UNITED STATES PATENT AND TRADEMARK OFFICE

APPLICATION NO.	FILING DATE	FIRST NAMED INVENTOR	ATTORNEY DOCKET NO.	CONFIRMATION NO.
10/631,828	08/01/2003	Fumio Miyagawa	300.1121	1714

Office Action Summary

DETAILED ACTION

Fig. 1

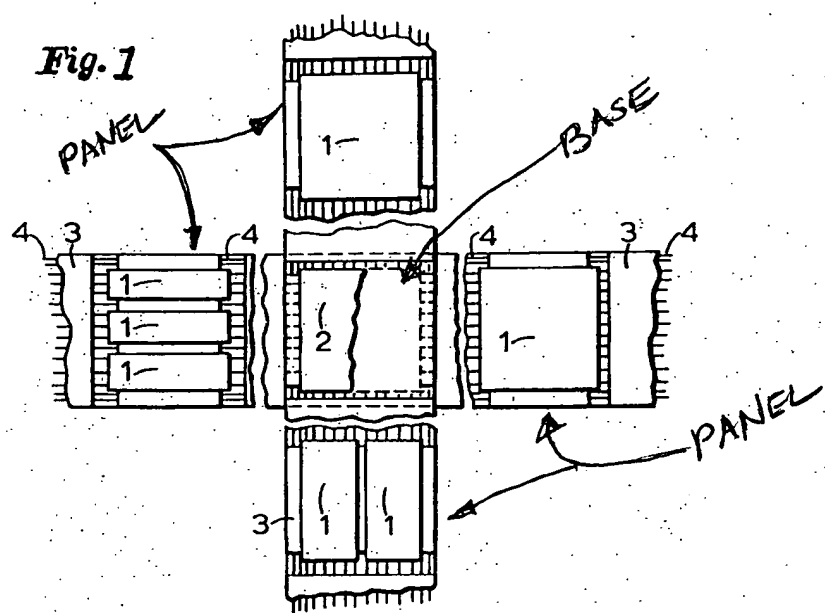
Regarding claim 16, Klehm, figure 1, a housing preform, comprising: a bendable plate member (overlying conductor strip), in a two-dimensional configuration, having a base (base, as marked on figure 1 in appendix "A") and panels (four regions around the cross formed by overlaying the strips, as marked on figure 1 in appendix "A") integral with the base (see figure 1), about bend lines defining a perimeter of the base (perimeter of the base), when bent, being commonly erected and interconnecting sidewalls relating to the base and together, with the base, forming the housing, and electronic components (1, 2) and interconnects (4) electrically connecting said electronic components being formed, on the base and panels (see figure 1, 2 and 3).
